## EMBREY BUILDERS, LLC.

RFI #: 117 Date: 5/15/2012 Job: EB-02 Keller Springs Lofts Phone: 877-777-5115

Subject: Structural Repair Needed at Step From Pour 3 to Pour 5

RFI RFI #: 133 To: Heath Parnell Date: 5/30/2012 Jordan & Skala Engineers, Inc. Job: EB-02 Keller Springs Lofts 14240 Midway Road, Suite 350 Dallas, TX 75244 Phone: 877-777-5115 Ph: 469/385-1616 Fax: 469/385-1615 cc: Erik Earnshaw (Beeler Guest Owens Architects) Subject: Supply and Return Air Grills on All Floors Drawing: M3.1, M3@, A3.1C, A3.2C, A3.3C, A3.4C Spec Section: Cost Impact: None Schedule Impact: None

RFI 117

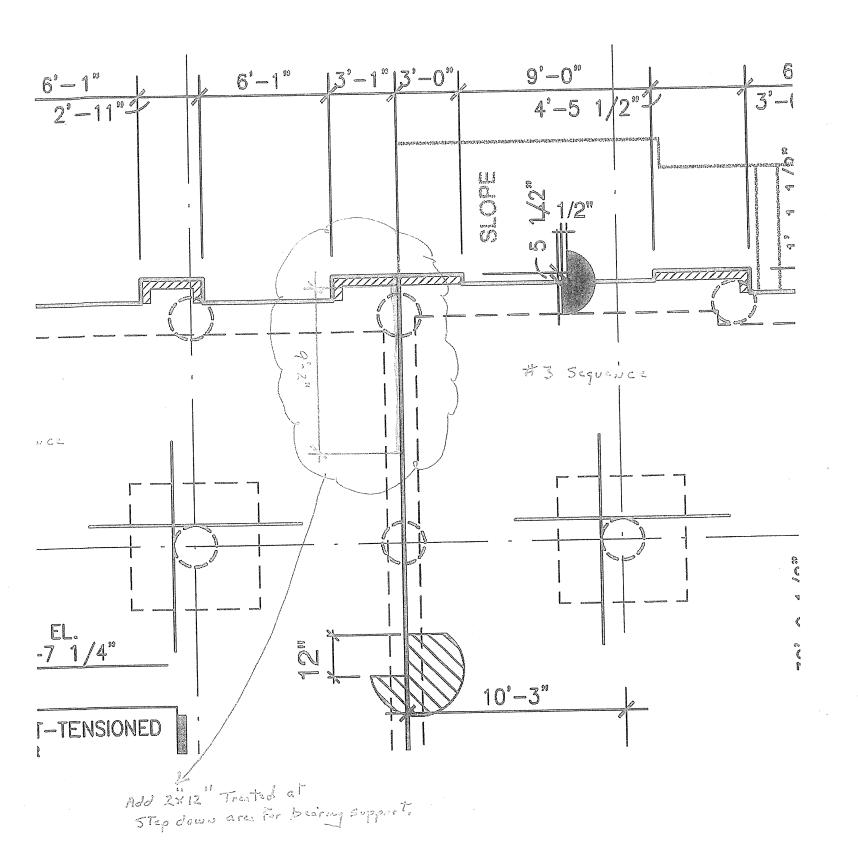
Date Required: 5/22/2012 Request: At the 12" step down between pour #3 and pour #5 the forms for pour #3 got out of square to the east of the proper line. At our site meeting on 5/11 with PPO (Brande Parkey) we looked at possibly using a treated 2x12 shot or anchored into the face of the #3 slab. This would be used for additional bearing for the 3 1/2" stud party wall for #3. Attached is the location with the dimension showing the length of the treated 2x12. Please advise and respond.

Attach vertical, pressure-treated 2x12's (cut so that the end of the 2x12's flushes out with the top of the concrete at the high side of the step) at 11 1/4" on center. Attach each piece of 2x12 with two 5/8"x6 1/2" Simpson Titen HD anchors (see sheet S1.1 for requirements) spaced at 6" on center vertically.
